Safety Evaluation Report, Revision 1

for the AUC LLC
Reno Creek ISR Project, Campbell County, Wyoming
Materials License No. SUA-1602

U.S. Nuclear Regulatory Commission
Office of Nuclear Materials Safety and Safeguards
Date Issued: February 2017

Figure 2.3-2 Regional Type-Geophysical Log

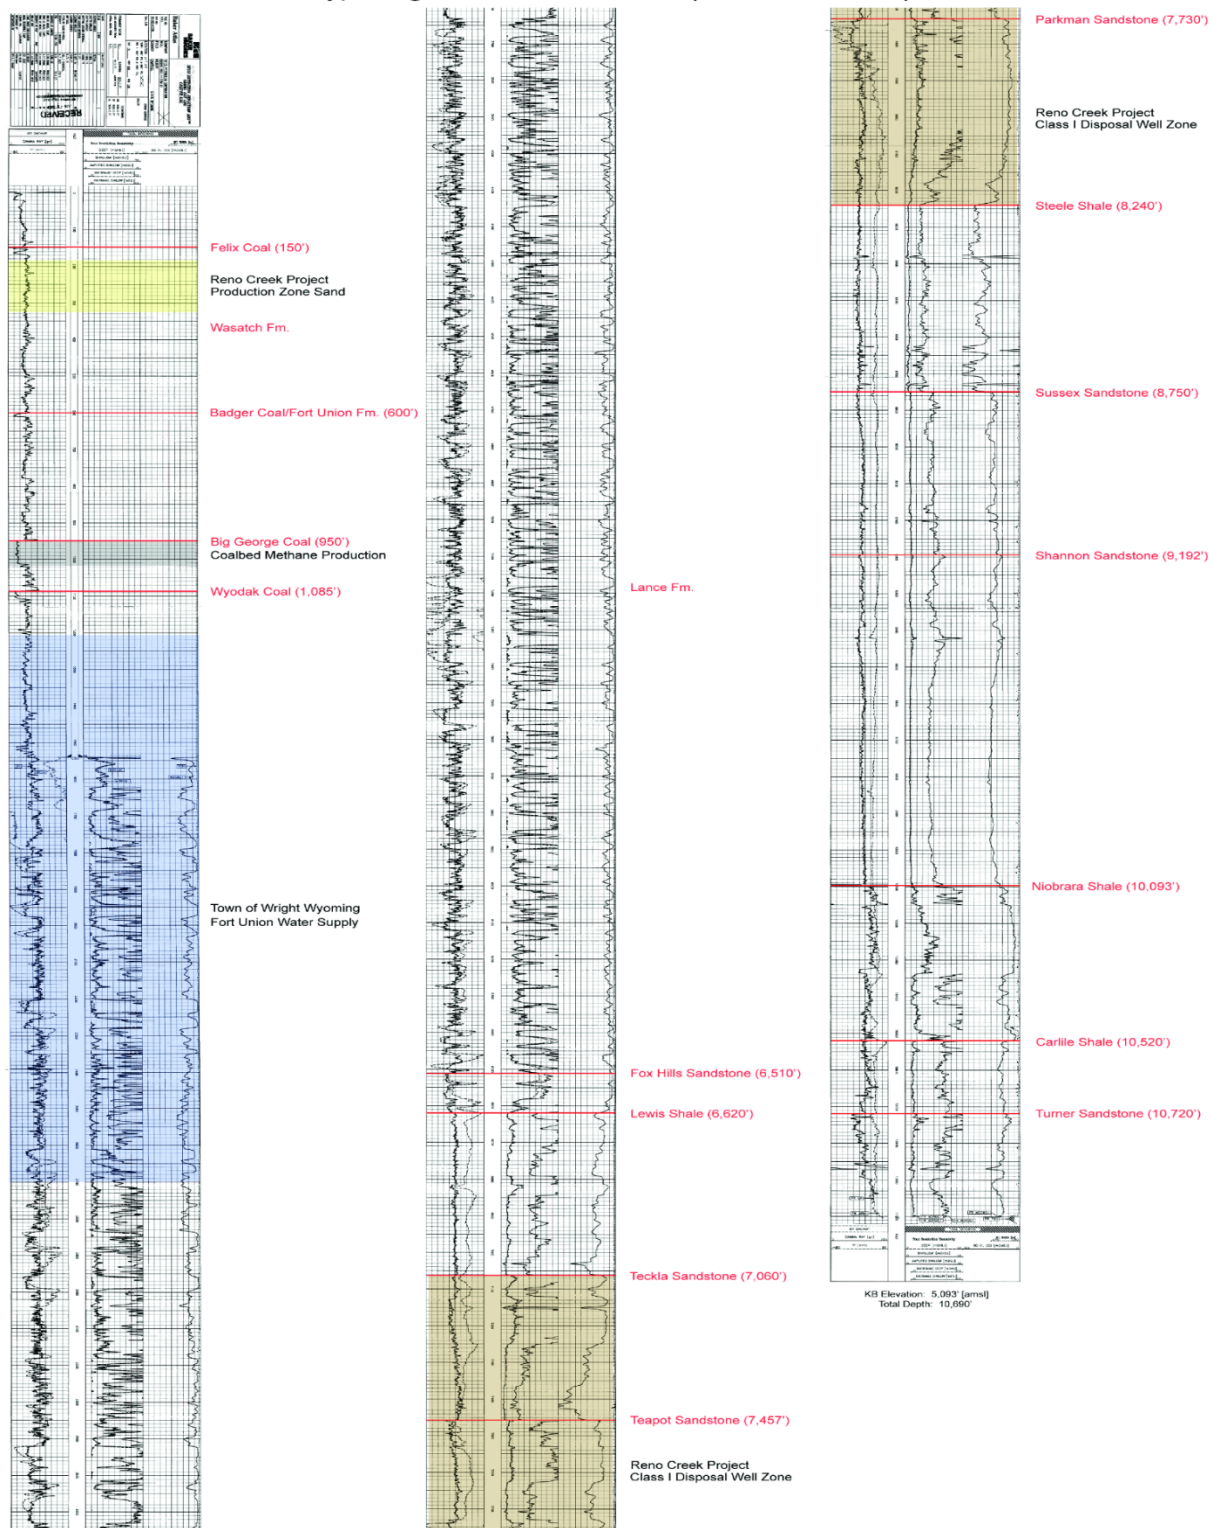
The applicant presents a geophysical log for an oil and gas well located within one-half mile of the Proposed Project as a regional type log (SER Figure 2.3-2). The log depicts the geophysical signature of the subsurface strata to a depth of approximately 3,200 m (10,500 ft). The applicant superimposed on that log locations of various geological formations, as well as the horizons significant to the Proposed Project. These horizons include the Felix Coal (in the upper confining unit), the production zone, the Badger Coal (top of the Fort Union Formation and production zone for the nearby CBM wells), the Wyodak Coal, the zone for the Town of Wright Fort Union Water Supply Wells, and the planned injection zone for the Proposed Project Class I injection wells (SER Figure 2.3-2).

Underlying the Wasatch Formation is the Fort Union Formation. The contact between the Fort Union and Wasatch Formations is the Badger Coal (SER Figure 2.3-2). The Badger Coal is equivalent to the Roland Coal mapped elsewhere in the Powder River Basin (AUC, 2012). The Fort Union Formation consists of clay-rich shales and sandstones with some extensive coal beds (AUC, 2012). The notable coal beds in the Fort Union Formation include the Big George Coal and the Wyodak Coal. The Big George Coal is the zone for CBM production in the Proposed Project and immediately surrounding area. The Big George Coal seam is approximately 305 to 335.3 m (1,000 to 1,100 ft) below grade, or approximately 183 m (600 ft) below the base of the Proposed Project production zone (AUC, 2012). In addition to the coal

Figure 2.4-4 2011 PZA Potentiometric Surface Contour Map

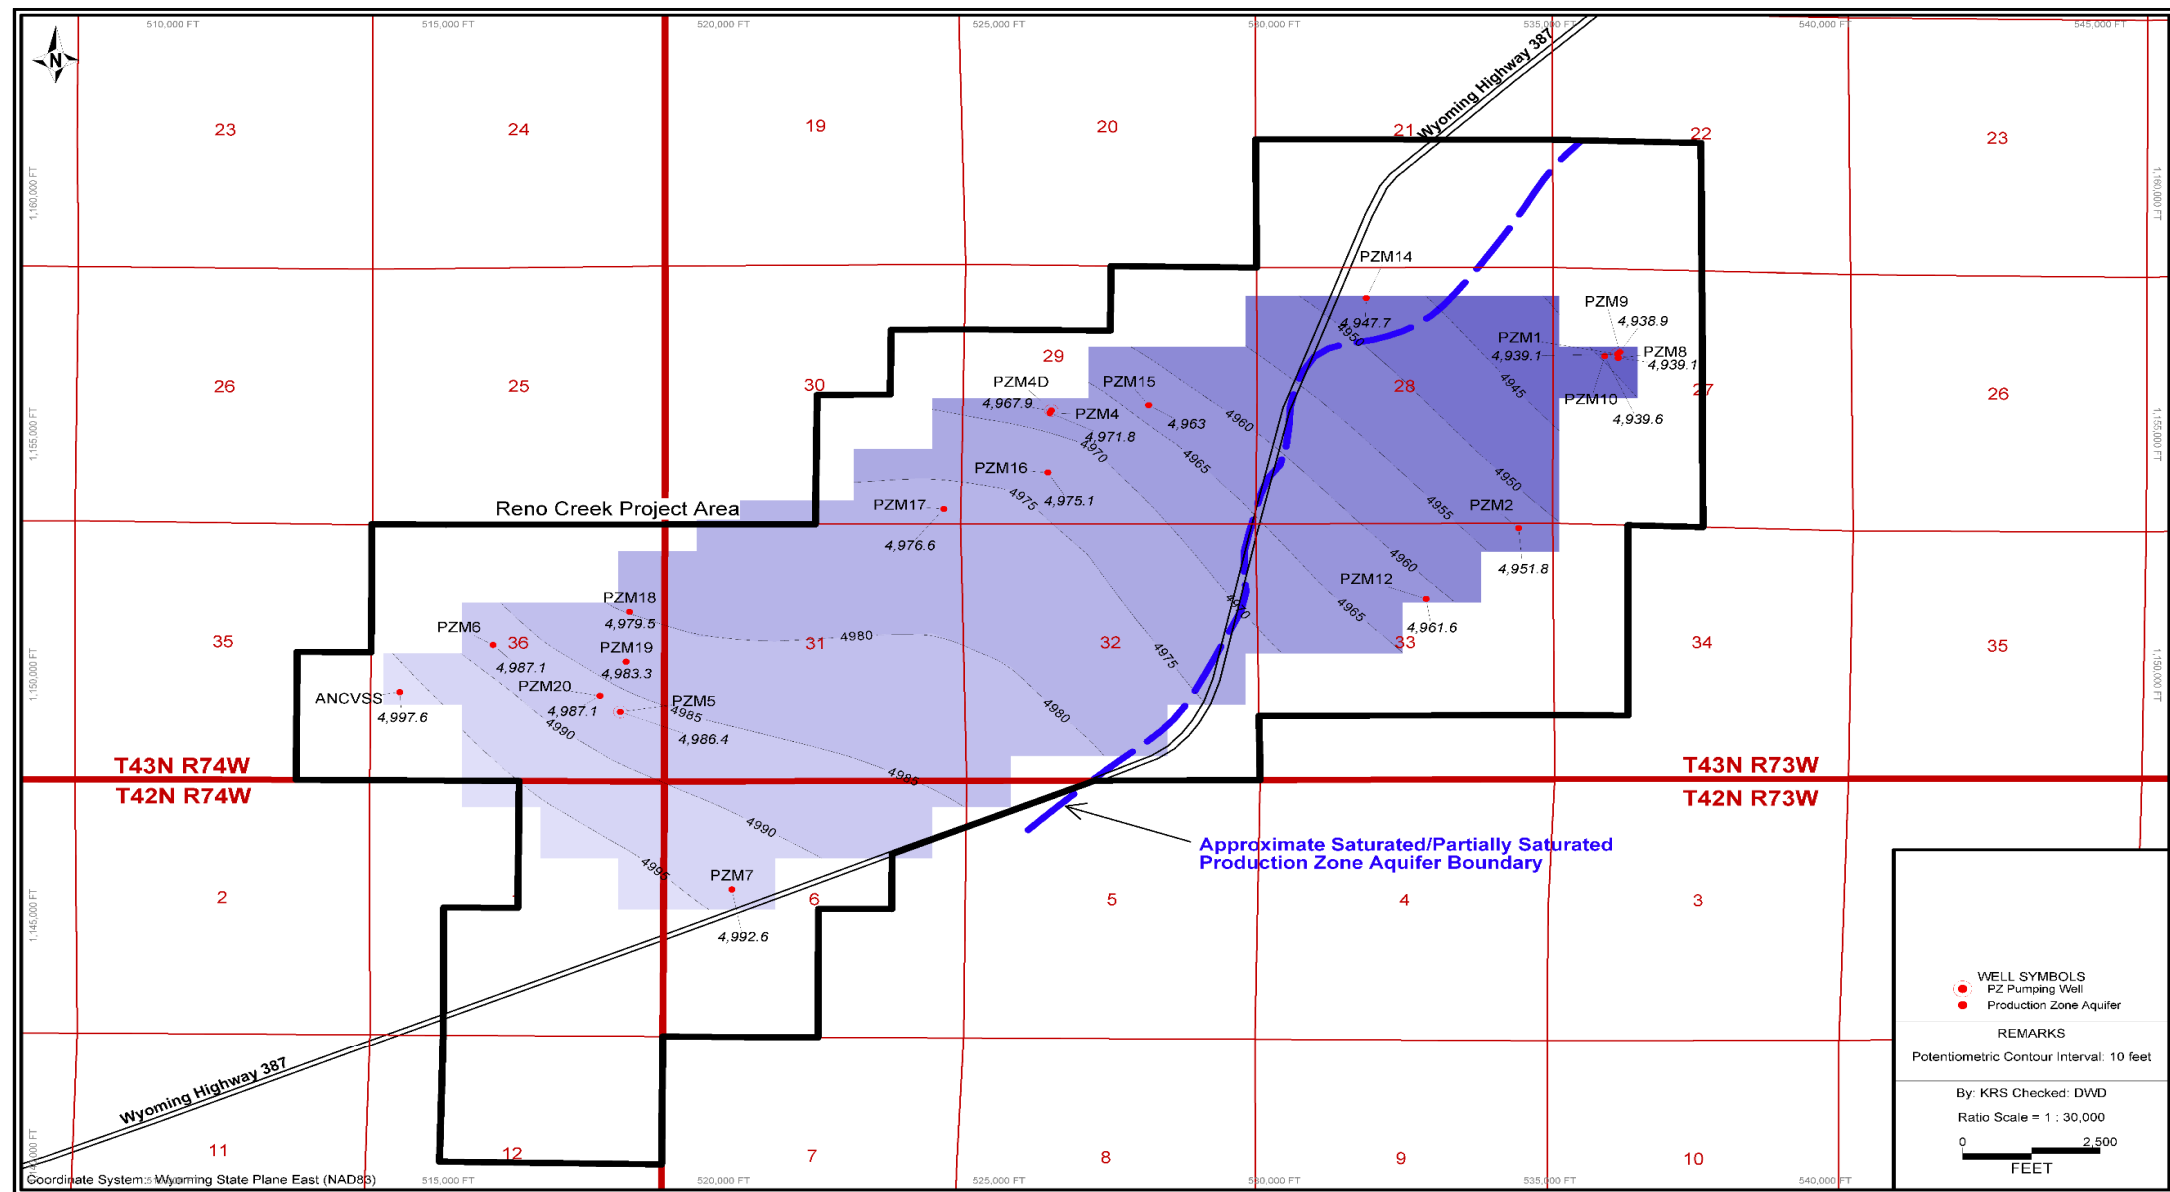
The applicant provided two potentiometric surface contour maps for the PZA (AUC, 2012). The first map is based on water levels measured by the applicant during August 2011 (SER Figure 2.4-4). The potentiometric surface contours depicted on that map indicate northeasterly flow with hydraulic gradients between 0.0017 to 0.0027 ft per foot. The flattening of the gradient is observed in the center of the Proposed Project area, which, the applicant states, is likely related to the presence of thicker and more transmissive sands.

Figure 2.4-5 1993 PZA Potentiometric Surface Contour Map

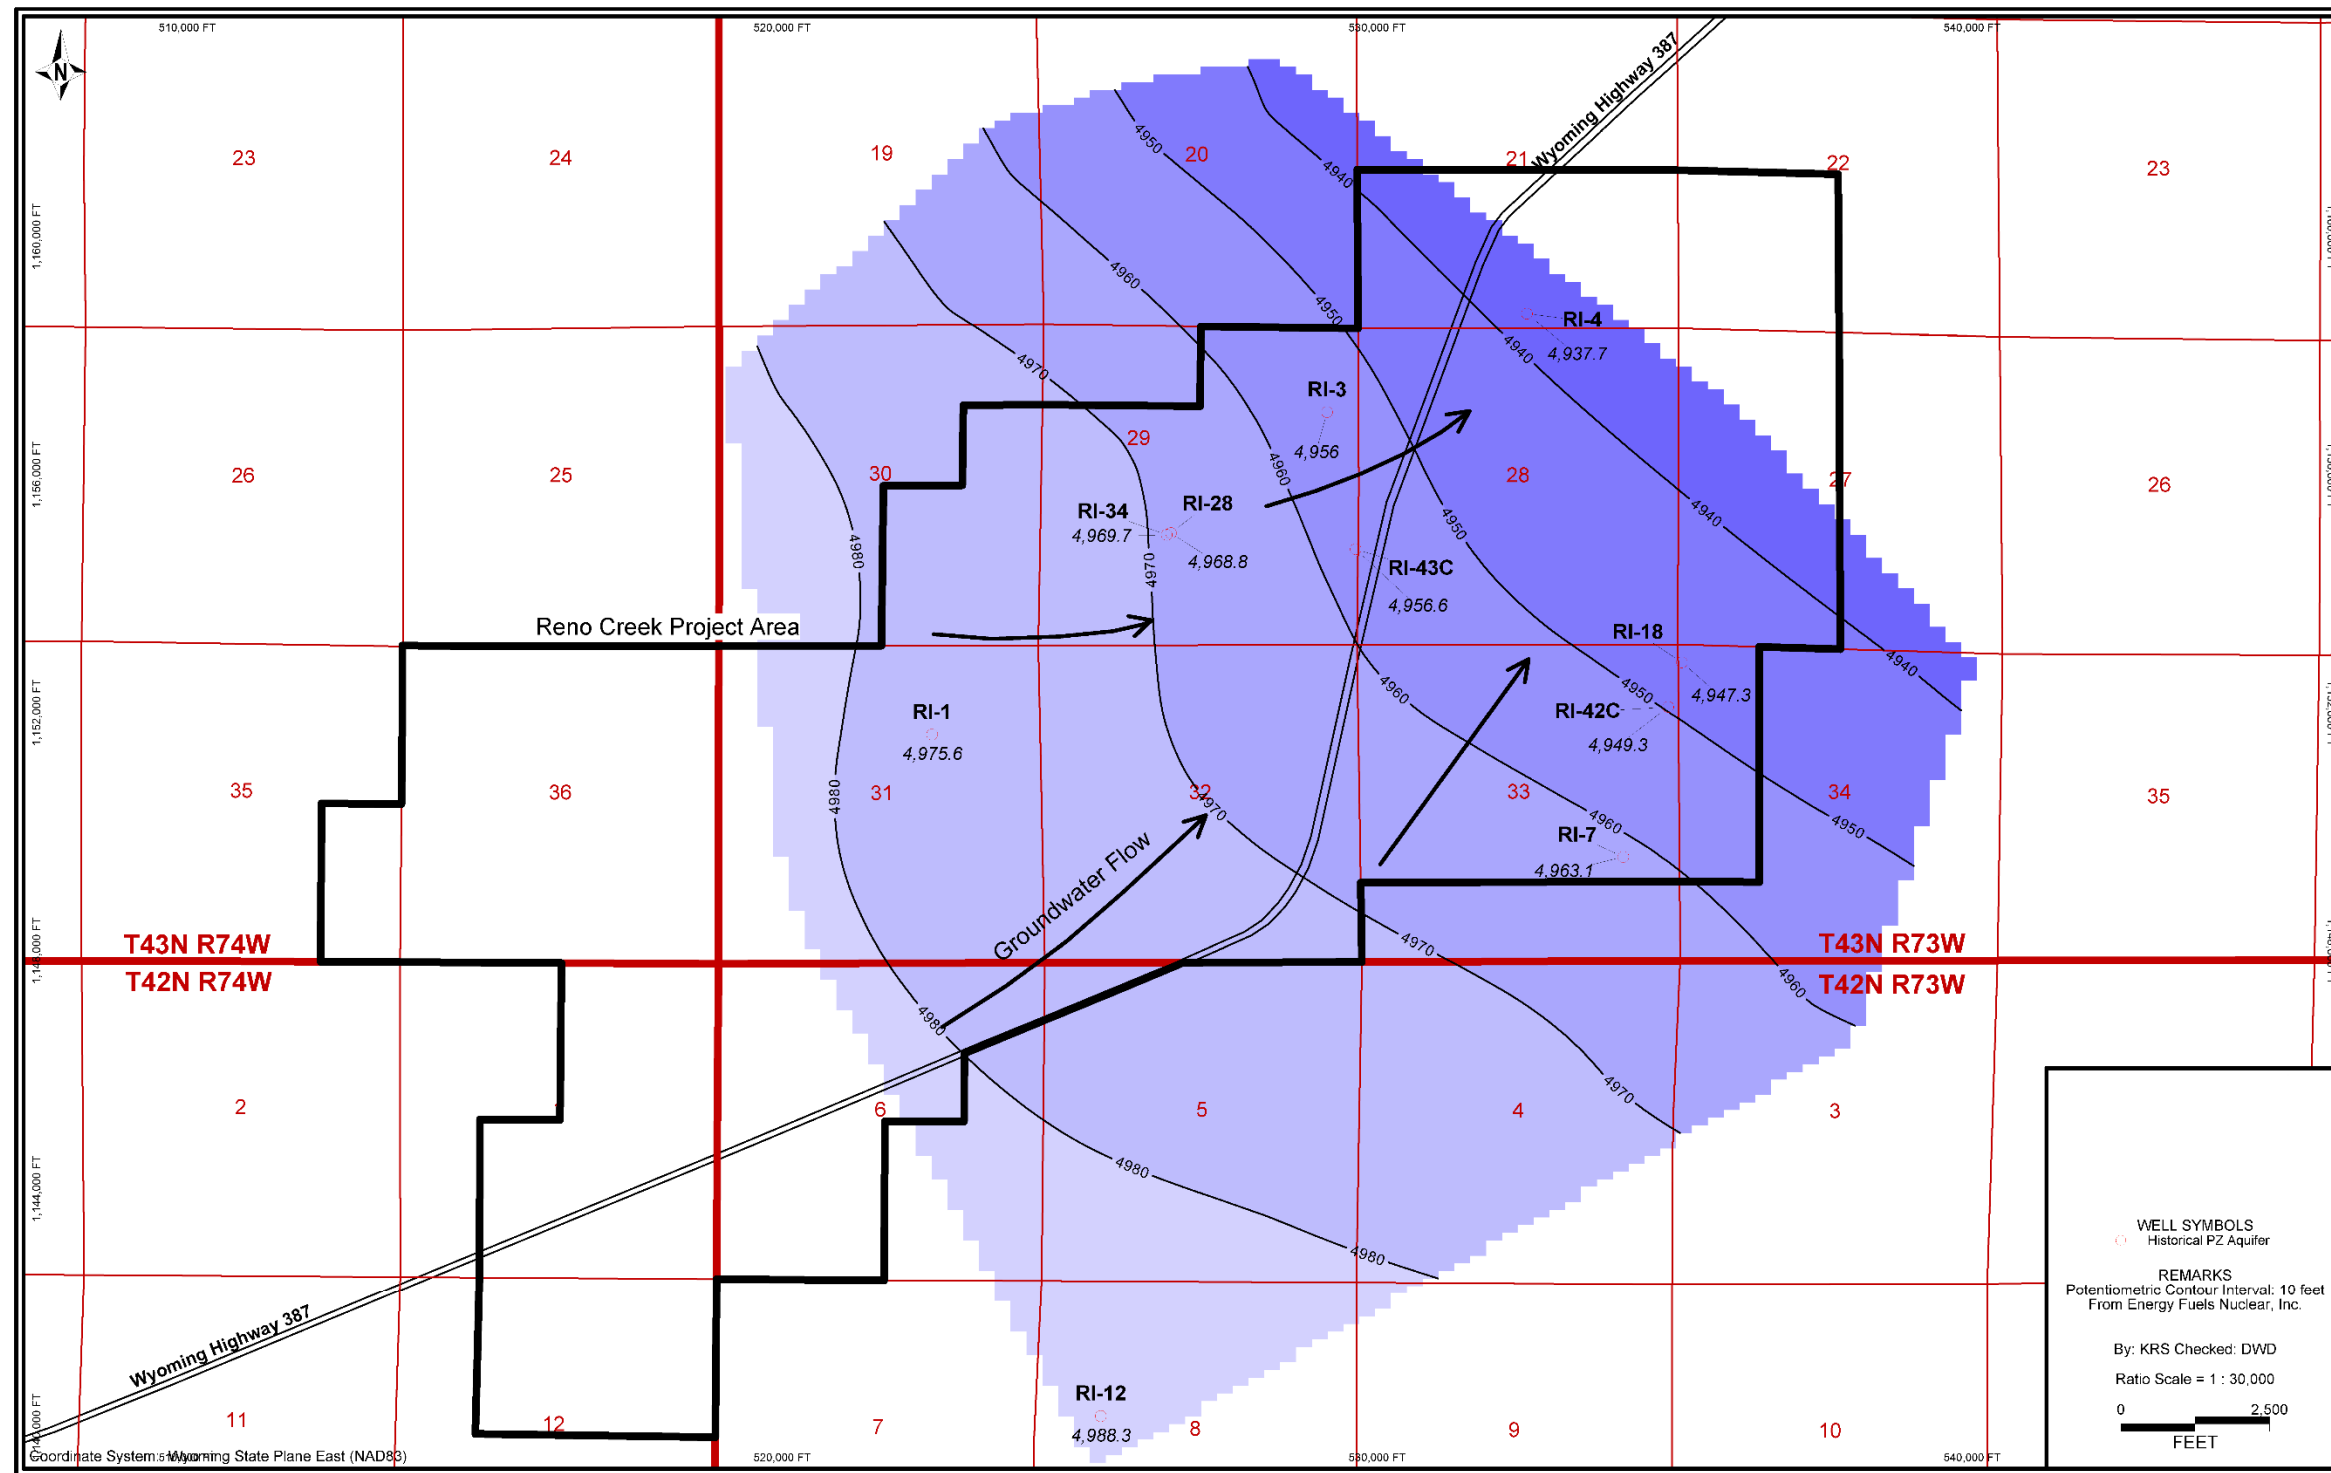
The second potentiometric surface contour map is based on water levels measured by a prior operator in October 1993 (SER Figure 2.4-5). The applicant states that flow directions and hydraulic gradients for the 1993 surface are similar to those based on the August 2011 surface (AUC, 2012).
